Defense Nuclear Facilities Safety Board Recommendation 2000-2, Vital Safety Systems Assessment Report for the Annular Core Research Reactor

**Report on  
Annular Core Research Reactor Ventilation System Assessment  
at the Sandia National Laboratories (SNL)**

**September 2002**

**Figure 1: HBVES and GIF Ventilation System Nominal Flow Rates**

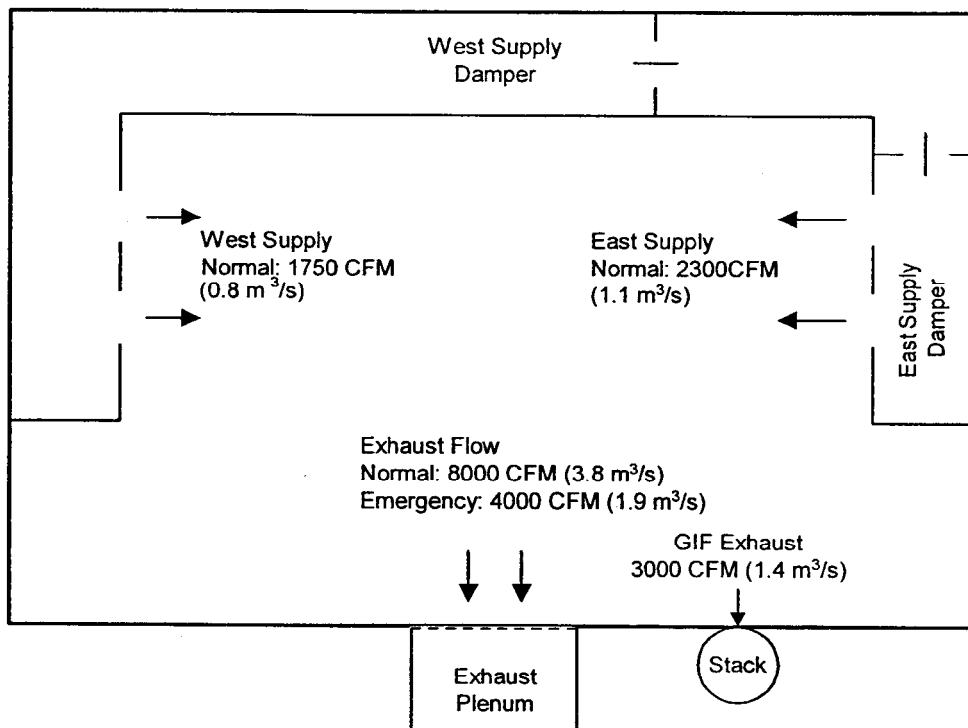
The airflow through the HVBES exceeded the airflow limits by as high as 25%. However, the BOP computer did not show that the airflow exceeded the expected value. The increased airflow challenges the allowable flow rate for the installed HEPA filter. The differential pressure across the HEPA filters was approximately 50% on the BOP of the measured differential pressure. The in-place leak tests for the charcoal adsorber beds in the CPS are not performed and their justification for omission is not documented. Periodic replacement of the adsorbers is being performed.

The system engineer or industrial hygienist should evaluate the number of room changes per hour in light of the modification that reduced the system flow rate. [OFI-VSS-ACRR-2]

**Figure 2: ACRR Cavity Purge System**

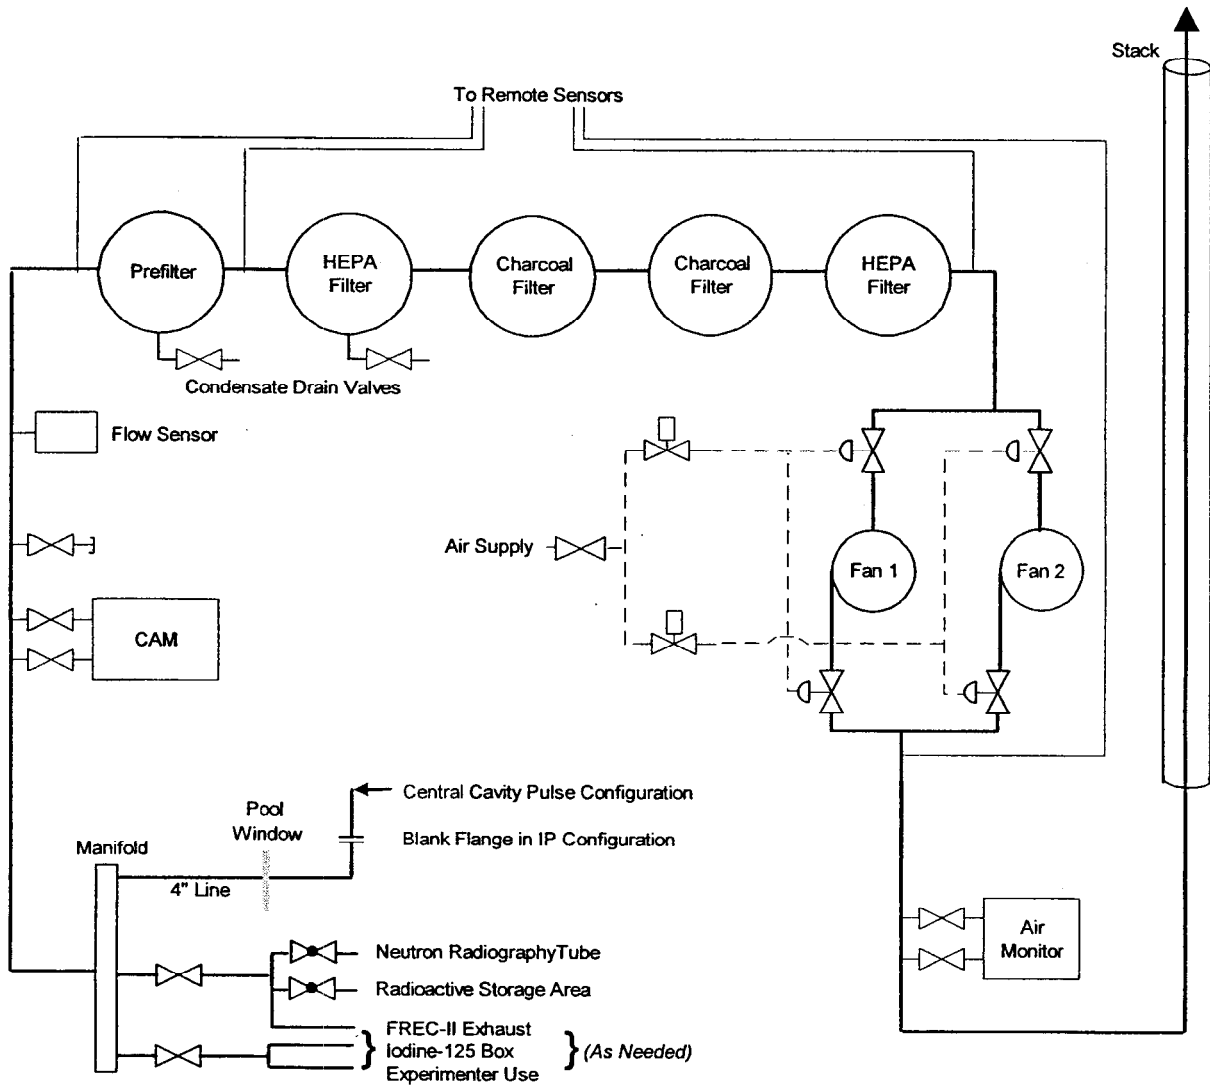
The operation procedure for charcoal replacement involves the replacement of one filter and the transition of the other filter. The bases for the transfer is if it has been in place for greater than three years. If the period is greater than three years for two consecutive replacements, then it will likely exceed 6 years total and violate the TSR LCO SR in the process. The procedure should be updated to replace the filters after thirty months to avoid exceeding 5 years for both changes. [OFI-VSS-ACRR-14]

Initial penetration tests showed a penetration of 0.17% on the upstream HEPA filter in the CPS which failed to meet the 0.02% criteria. The fluid seal was repaired and subsequent tests met specifications. The former GIF Ventilation System initial penetration test showed 0.086%. Specifications were met after gasket repair. The initial airflow measurement of the HBVES indicated a flow 5.4% greater than the maximum allowed. Subsequent adjustment of a balancing damper reduced the airflow to within the specifications. The final test results show conformance with the test specifications, however, since the penetration test procedure did not follow the intent of the required test standard, the penetration performance is questionable. The pressure differentials and flows are within specification limits. Adsorber bank in-place leak tests were not performed so performance cannot be verified.
